**SUBJECT: DAVIS-BESSE NUCLEAR POWER STATION - INSPECTION TO EVALUATE
THE ROOT CAUSE EVALUATION AND CORRECTIVE ACTIONS FOR
CRACKING IN THE REINFORCED CONCRETE SHIELD BUILDING OF THE
CONTAINMENT SYSTEM 05000346/2012009(DRS)**

Report No: 05000346/2012009

Facility: Davis-Besse Nuclear Power Station

Picture No. 4 – Davis-Besse Shield Building Impulse Response Testing Mobility Plot

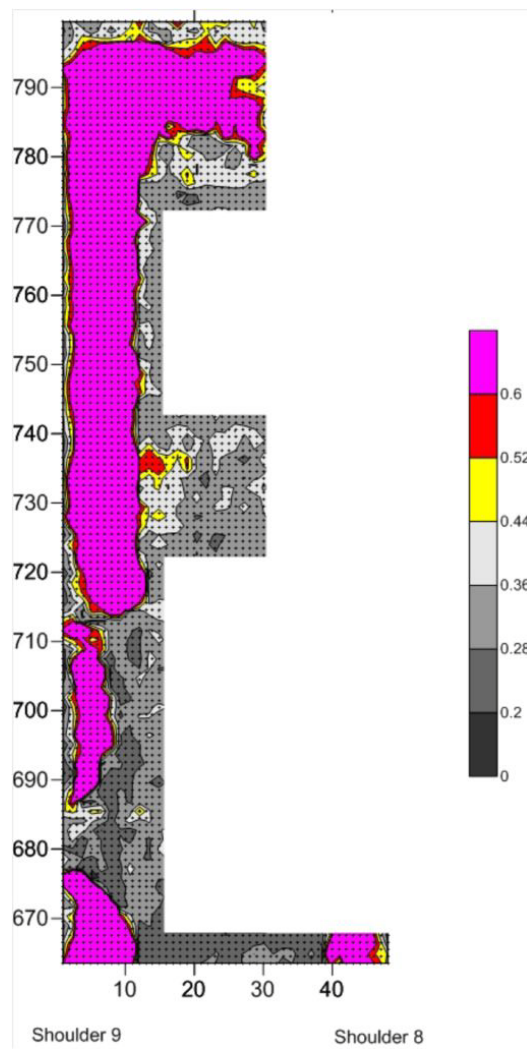
- The NRC team reviewed the IR mapping results (Attachment 2, Pictures 4 and 5) and SB drawings identifying the location and configuration of structural reinforcement (e.g., rebar) to determine if the extent of laminar cracking identified was consistent with the RCT conclusions that SB reinforcement design features contributed to the extent of cracking observed. The NRC team confirmed that the extent of cracking identified by IR testing results was consistent with the RCT identified Contributing Causes. However, the NRC team identified areas of laminar crack indications between SB shoulders 6 and 7 and above the mainstream line penetrations which did not include sufficient IR test locations to link this area directly with cracked areas in the adjacent SB shoulder regions. The NRC team's observation related to a lack of IR coverage did not invalidate the theory for the Direct Cause of the cracking or the Contributing Causes because the extensive computer modeling and vendor CBS testing provided a sufficient basis to validate these causes. Specifically, five analyses were completed in support of the SB laminar cracking causes Freezing Failure and Rebar Spacing Sensitivity Study, Structural and Thermal Analysis Investigation, Stress State During 1978 and 1977 Blizzards, Stress Analysis Due to 105 mph Wind Load, and Laminar Cracking Due to 1978 Blizzard. Therefore, the NRC team concluded that the RCT had developed a sufficient basis for the Contributing Causes.

Picture No. 10 – Davis-Besse Shield Building – Water Migration

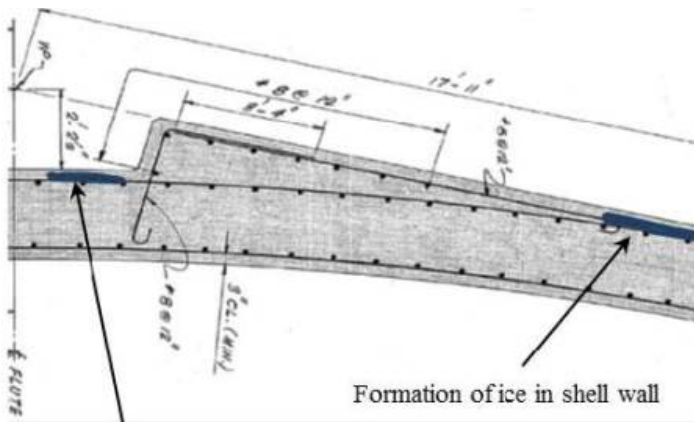
- The NRC team confirmed that weather records existed which supported the Direct Cause related to the extreme environmental conditions associated with the blizzard of 1978. This blizzard occurred from January 25 – 27, 1978, and produced rain with sustained winds, followed by rapid temperature drop and significant snowfall. Specifically, snowfall amounts ranging from 12 inches in Toledo to 22 inches at Saginaw, Michigan were recorded with wind speeds of 45 miles per hour (mph) and gusts to 105 mph west of Toledo, Ohio. This blizzard was preceded by a rapid drop in temperature beginning at 12 noon on January 25, 1978, and ending at midnight January 27, 1978. The vendor report included temperature maps that record a temperature drop from 40 degrees Fahrenheit (°F) at about 6:00 pm on January 25, 1978, to about -5° F by midnight. Daily temperatures were below 20° F by noon on January 26, 1978, and surface temperature continued to drop to near 0° F by midnight on January 27, 1978. These environmental conditions enabled moisture to penetrate the SB concrete, freeze and expand, which created a radial stress that exceeded the tensile strength of the concrete triggering the subsurface laminar cracking (Attachment 2, Pictures 10, 11 and 12).

Picture No. 11 – Davis-Besse Shield Building – Location/Progression of Ice Formation

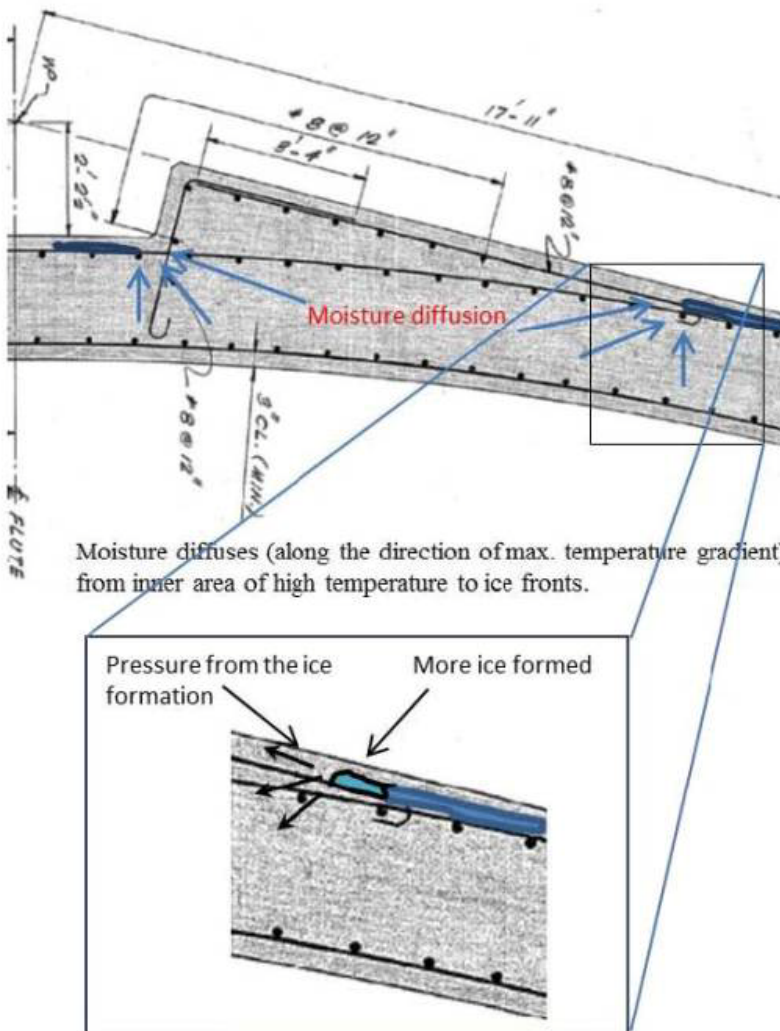
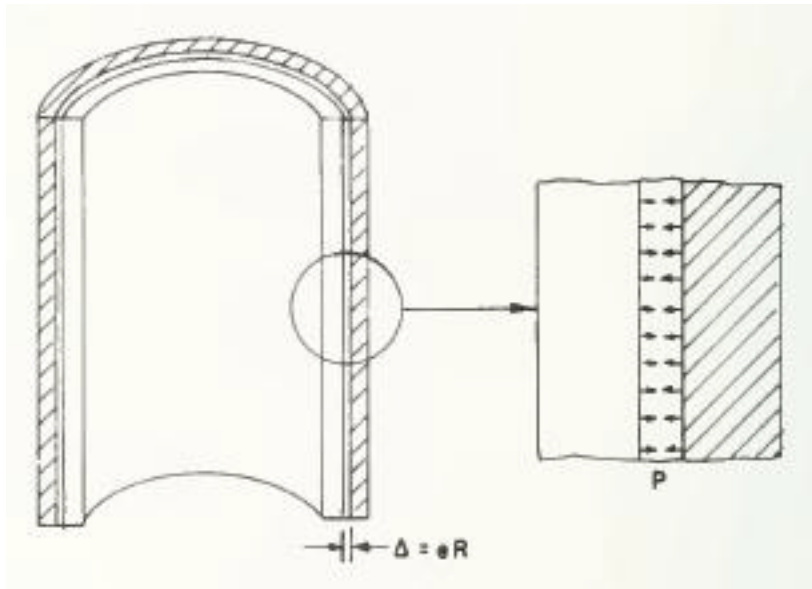
The RCT concluded that the Direct Cause for the SB concrete laminar cracking was the integrated affect of moisture content, wind speed, temperature, and the duration of these conditions created during the blizzard of 1978. The environmental conditions created by the blizzard of 1978 enabled moisture to penetrate the SB concrete, freeze and expand, which created radial stresses that exceeded the tensile strength of the concrete and initiated the subsurface laminar cracking (Attachment 2, Picture 11).
